**Re: Fourth Technical Corrections Review – APS 6-12 at Fitzsimons – Advisory Site Plan**  
Application Number: **DA-1233-39**  
Case Number: **2019-6008-00**

## Fourth Technical Submission Review

B. URSULA STREET / TYPICAL MID-BLOCK SECTION ::

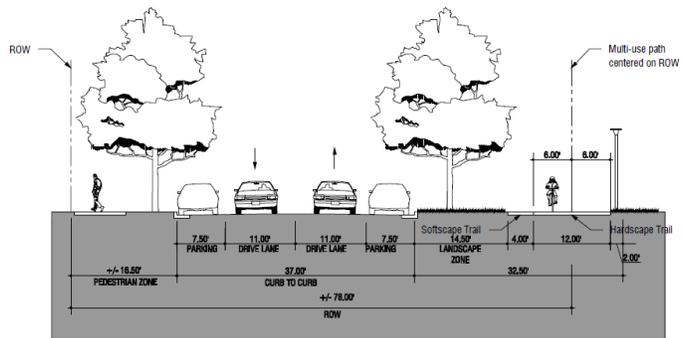
E. In addition to design guidelines, the GDP provides typical street sections for primary streets on the campus. The Ursula Street and Scranton Parkway sections are provided here as they abut the eastern and western edges of the APS site. The expectation of the DRB, and correspondingly the City, is that these street sections would be constructed to be consistent with the design guidelines as well as the GDP. Street sections were considered as part of the Master Traffic Impact Study and designed to accommodate the unique needs of an urban campus. As currently constructed, the Ursula Street section abutting the APS school site does not comply with the required pedestrian and landscape zones as set forth in the GDP and the design guidelines.
